HISTORIC AND DESIGN REVIEW COMMISSION

HDRC CASE NO: 2018-290
ADDRESS: 416 E DEWEY PLACE
LEGAL DESCRIPTION: NCB 1732 BLK 5 LOT 4 & W 19.4 FT OF 5, 6 & E 36.2 FT OF 5
ZONING: MF-33 H
CITY COUNCIL DIST.: 1
DISTRICT: Tobin Hill Historic District
APPLICANT: Luis Elizondo
OWNER: Luis Elizondo
TYPE OF WORK: Installation of a 21 foot tall sculpture in front yard
APPLICATION RECEIVED: May 29, 2018
60-DAY REVIEW: July 28, 2018
REQUEST:

The applicant is requesting a Certificate of Appropriateness for approval to install a 21 foot tall freestanding sculpture with a lighting element in the front yard of 416 E Dewey Place.

NEW SCULPTURE
LOCATION

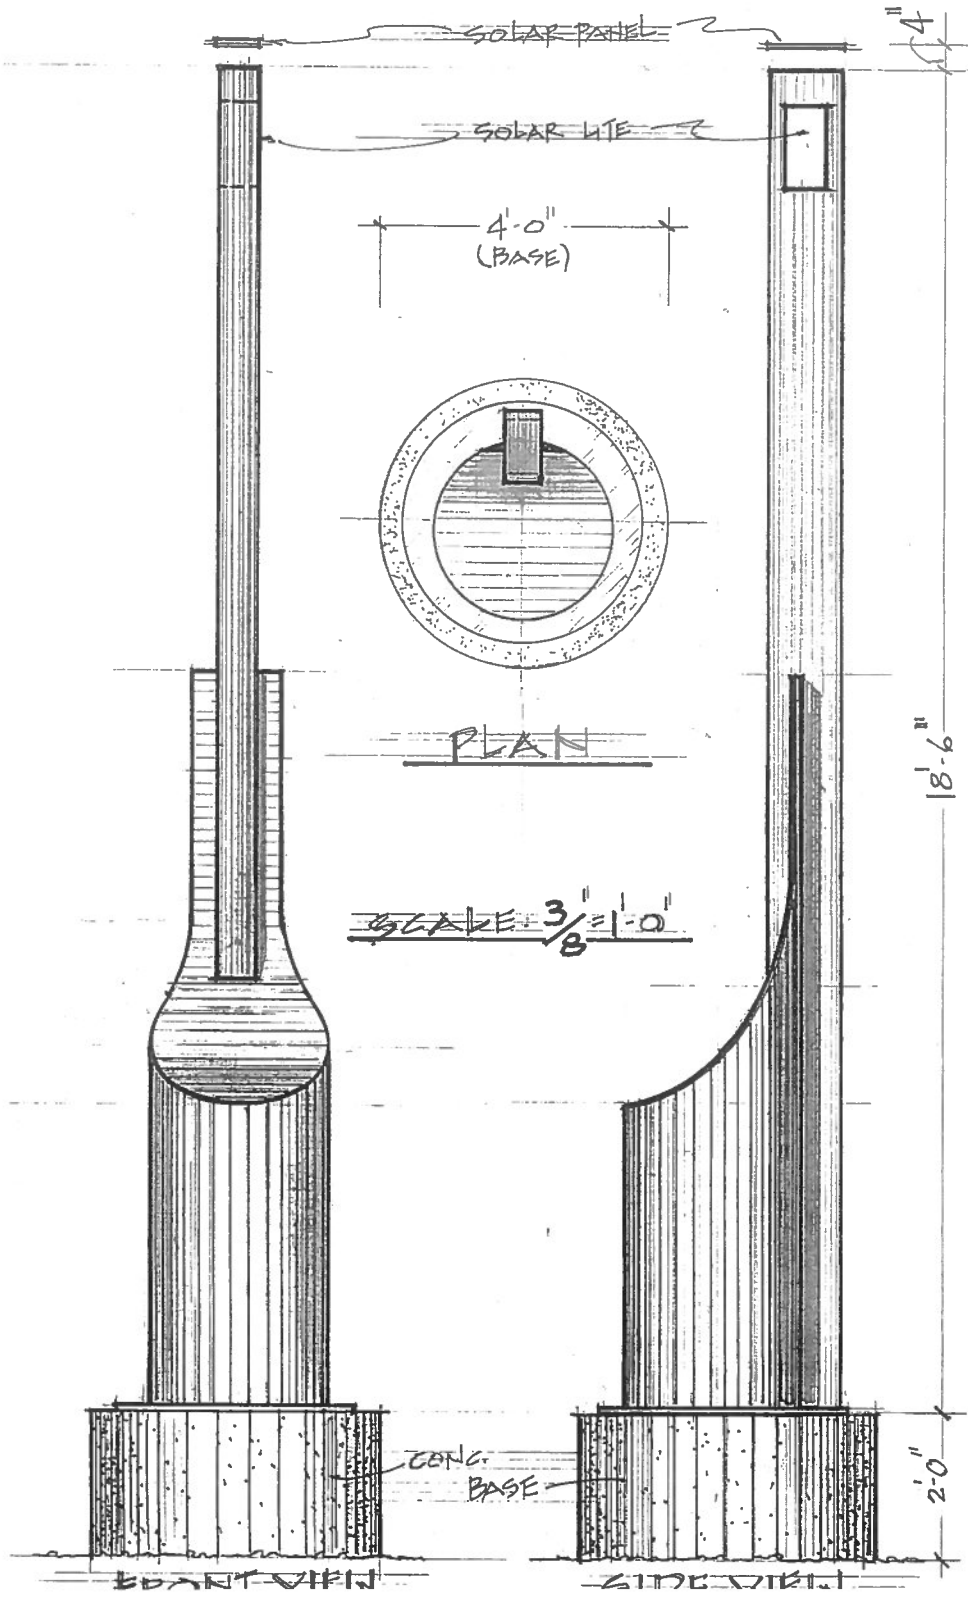
- b. LOCATION – The proposed structure is located in the front yard fronting Dewey, to the east of an existing concrete walkway. Per the Historic Design Guidelines, new site elements should not obscure or detrimentally affect the view of the historic structure from the public right-of-way. Due to the design of the sculpture, which includes a thin profile, the structure will not negatively impact the historic structure. Additionally, the sculpture is freestanding and not attached to the historic structure in any way, making it fully reversible. Staff finds its placement acceptable.

A SCULPTURE

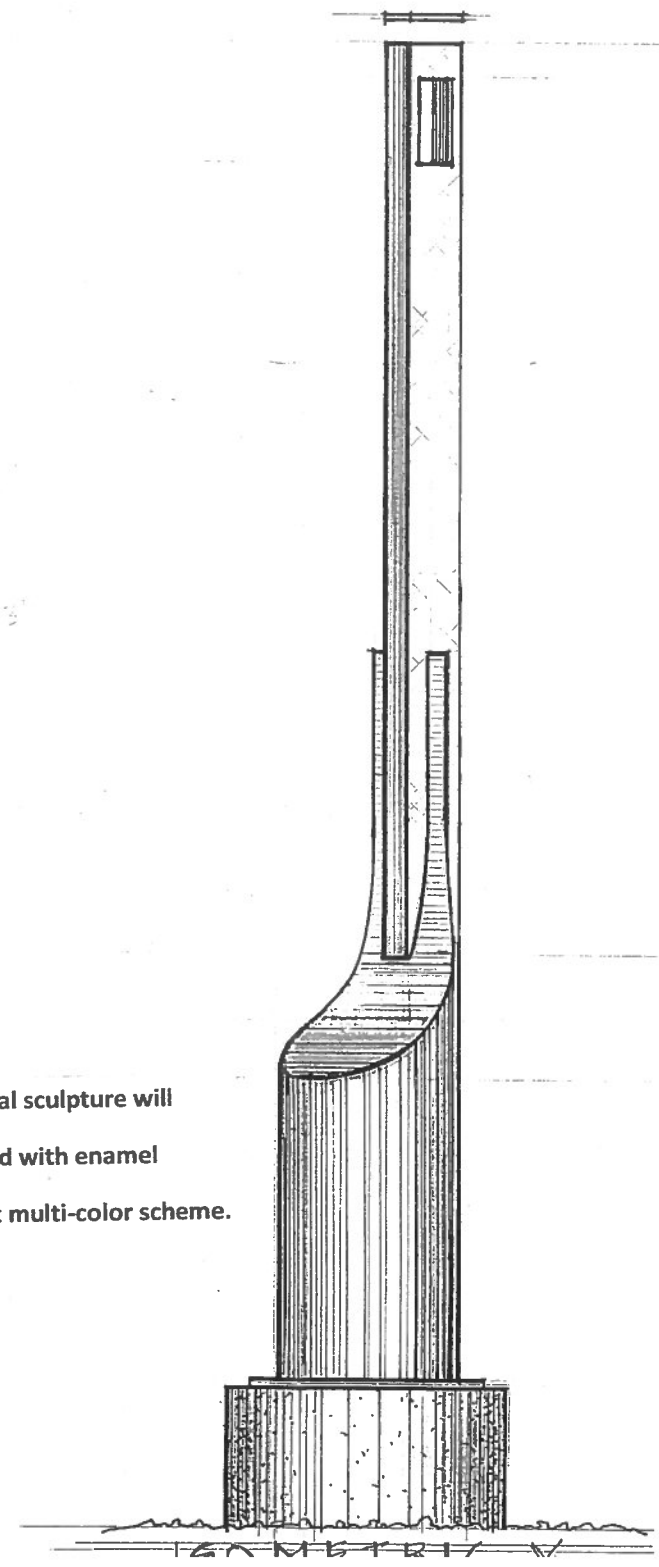
- d. DESIGN – The proposed structure features a four (4) foot wide circular base that tapers to less than one foot in width at the tallest point. As noted on the drawings, the sculpture will be made of metal and will be hand painted with enamel paint in a bright, multicolor scheme by a local artist. Staff has not yet seen a proposal for the colors. Generally, staff finds the design to be appropriate.

- e. LIGHTING – The submitted drawings indicate a small solar panel at the top of the sculpture and a solar lite, which would illuminate at night. Staff requires more information on the color, finish, size, and brightness of the proposed light element, but finds its location and use generally acceptable with the stipulations listed in the recommendation.

- i. That the structure be installed in a way that is fully reversible and does not structurally affect the primary structure.
- ii. That the applicant provides staff with final details regarding color and finish of the sculpture, as well as details on the solar light element, including color, finish, size, and brightness, prior to receiving a Certificate of Appropriateness.
